Determination 2019/025

Regarding the compliance of an infinity pool at 335C Te Hutewai Road, Raglan and whether to grant a waiver in relation to the means of restricting access

Figure 1: The pool's infinity edge and balance tank during construction

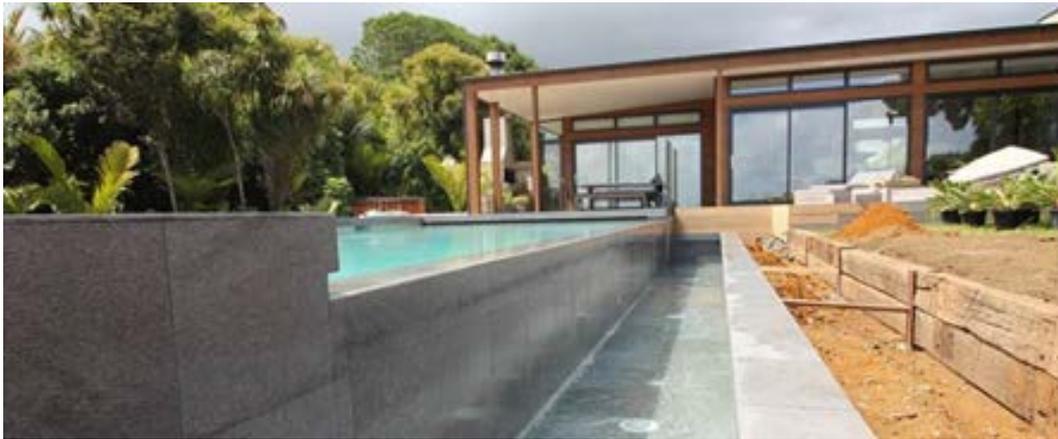
2.3 Figure 1 (at the start of this determination) shows the pool's infinity edge and balance tank during construction and before glass barriers were installed at each end.

Figure 2: Balance tank and infinity edge as designed – detail of consented plans

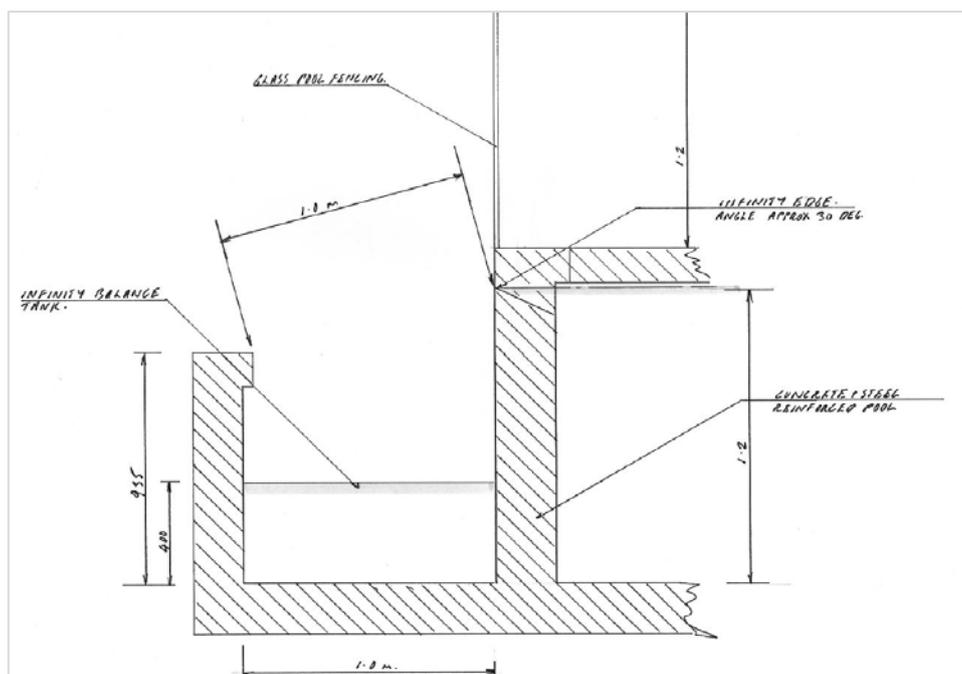
2.4 Figure 2 below shows a detail of the consented design, while Figure 3 shows the as-constructed dimensions as supplied by the agent. As constructed, the balance tank's walls are 935mm high instead of 800mm, and the tank itself has an internal width of 1000mm instead of 1200mm. No formal amendment or minor variation to the building consent was sought for these changes to the approved design.

- 5.1.1 To recap, the consented plans for the applicants’ pool include a balance tank designed with 800mm high walls and a 1200mm internal width. Instead, this tank was built with 935mm high walls and an internal width of 1000mm, making its walls closer to the infinity edge and calling into question whether this provides an adequate physical barrier to the pool.
- 5.1.2 The agent’s application for determination focuses on the infinity edge: the agent has suggested installing an audible alarm across this edge to reduce risk to unsupervised young children accessing the pool and has put forward arguments to support the request for a waiver of Clause F9’s requirements.

5.3.5 In my view, the outside walls of the balance tank are climbable objects as they are only 935mm high and have 240mm flat tops that are wide enough to stand on. Applying F9/AS1 Figure 2 (which gives acceptable methods for evaluating the requirements of paragraph 2.1.6) it is apparent that the tops of these walls are within a 1200mm radius of the infinity edge. As a result, the design of the pool barrier is not an Acceptable Solution and must be assessed as an alternative solution.

- 5.3.8 The agent is of the view that despite the balance tank wall being within 1200mm of the infinity wall it would be difficult for a child to step from the balance tank wall to the infinity edge. Given the distance between the balance tank and the infinity edge and that the infinity edge does not present a flat surface on which to stand, it may indeed be the case that it is difficult for children to step from the balance tank wall onto the infinity edge. However, the height of the balance tank wall combined with the distance from the infinity edge means that the balance tank wall would assist children in negotiating the barrier. There is nothing in the design limiting the ability of children standing on the edge of the balance tank wall from reaching and climbing from the balance tank wall over the infinity edge of the pool, and I consider that as an alternative solution it does not achieve the performance requirement.

- 5.3.9 I therefore conclude that the pool as constructed, and which is not in accordance with the consented plans, does not comply with Clause F9.3.1 or F9.3.2(a). The pool does not have a physical barrier that surrounds the pool and that restricts access to the pool by unsupervised children under 5 years of age.
